CITY OF ALBUQUERQUE

Planning Department
Brennon Williams, Director

RE: 1310 Cuesta Arriba Court NE
Grading and Drainage Plan
Engineer's Stamp Date: 12/05/19
Hydrology File: D16D103

SHEET
GRADING
PLAN
C100

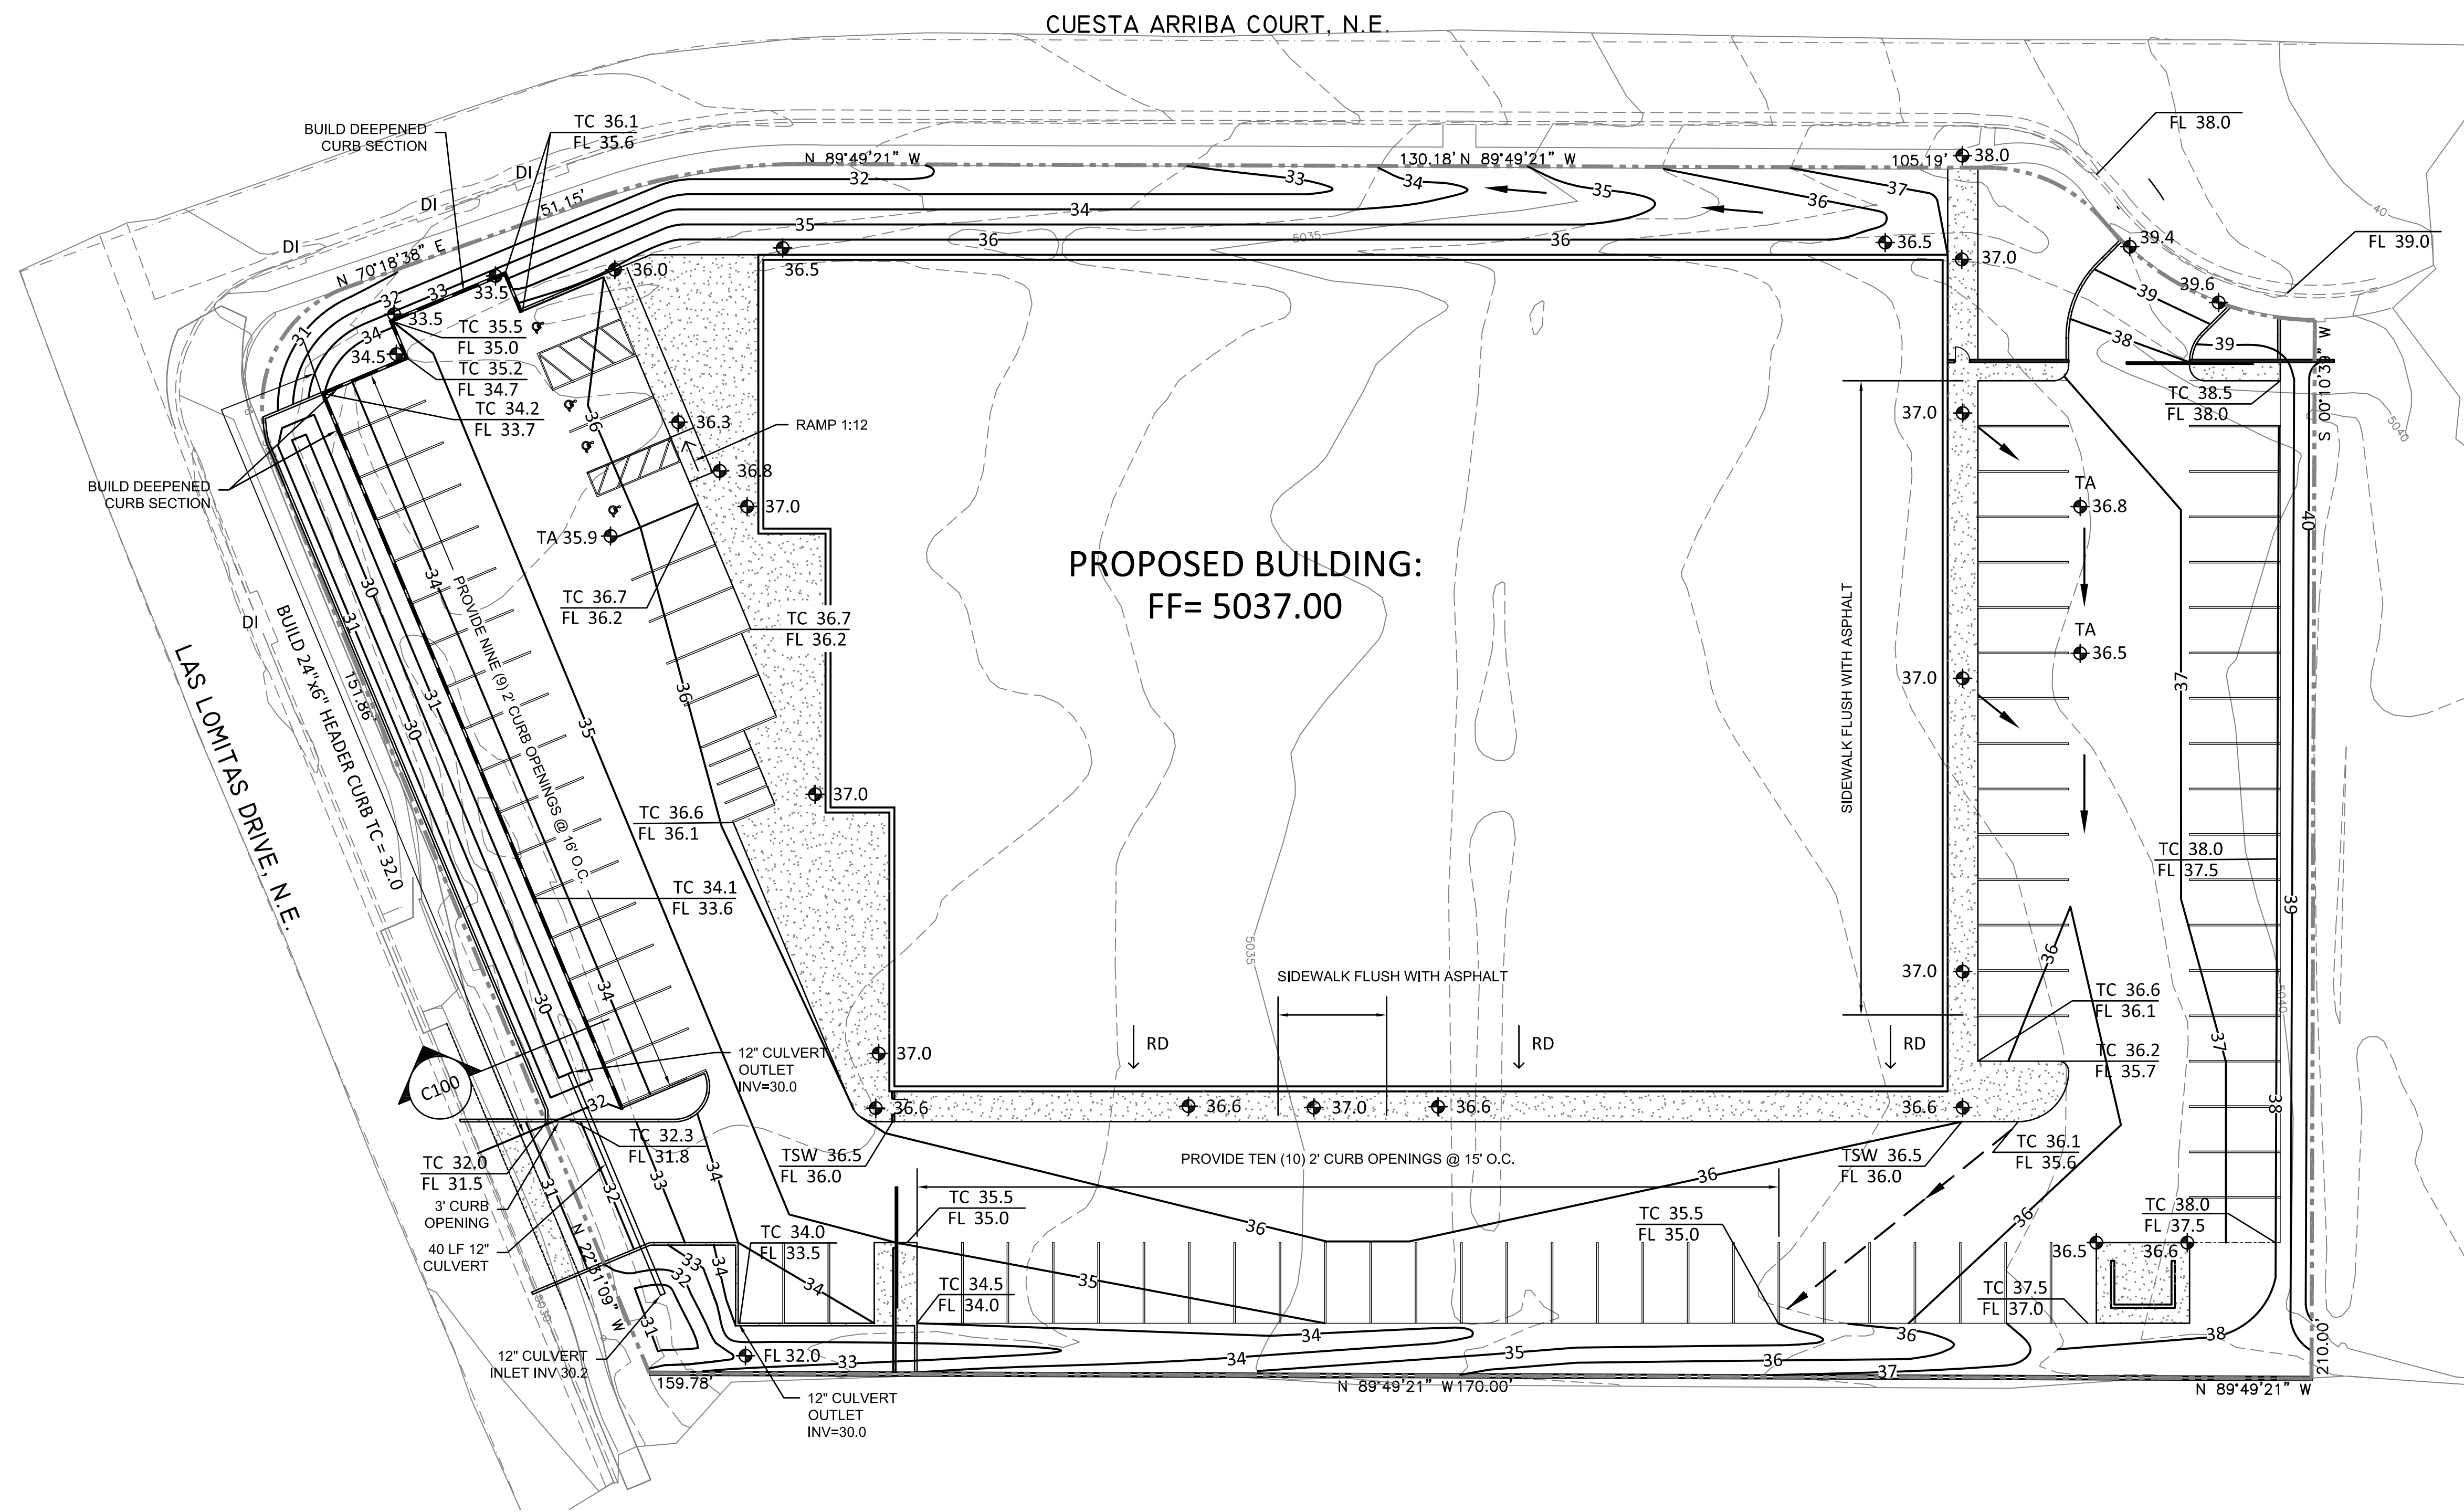
1. There is an existing electrical transformer which is not shown in the southwest corner of the tract. The proposed stormwater quality pond will have to be adjusted. See photo below.

2. There is no existing sidewalk along Cuesta Arriba Court. You show this as existing. Please show the proposed required frontage sidewalk. See photo below.

3. Please provide adjacent property information. This is missing.
4. Please correct both driveways. They are not tied into the existing curb with the proper commercial radius.

5. Please show the on-site curbing. It is hard to tell what is curb and what is flush with the sidewalk.
6. Please correct some of the proposed contours. They are not being tied into the existing contours.

7. Please provide a detail of the non-typical deepened curb.
8. Please change all reference of First Flush to Stormwater Quality. This is the current terminology.

9. Please label the Stormwater Quality Ponds with the provided volume.
10. Please provide an emergency spillway for the Stormwater Quality Pond. Typically this is a 2 feet sidewalk culvert. Also please label this per CoA detail 2236 and include both the inflow and outflow at the gutter.

11. Please check all callouts. Most are unreadable because of the line work that they are over.
12. Please label the existing retaining wall along the southern property line. See photo in comment #1.

13. Please provide a cross-section for this existing retaining wall through the proposed swale and the proposed parking.

14. Please add the Stormwater Quality Volume WSE in the Pond Section.
15. Please provide the weir calculations, per DPM Chapter 22.3.A.1, for the curb cuts and sidewalk culverts. A coefficient of 2.7 is typically used for the weir equation $Q = CLH^{2/3}$.
16. There appears to be an area along Cuesta Arriba Court which does not go into a Stormwater Quality Pond and instead point discharges into the street. Please see if a small pond is needed for this drainage.
17. Standard review fee of \$150 will be required at the time of resubmittal.
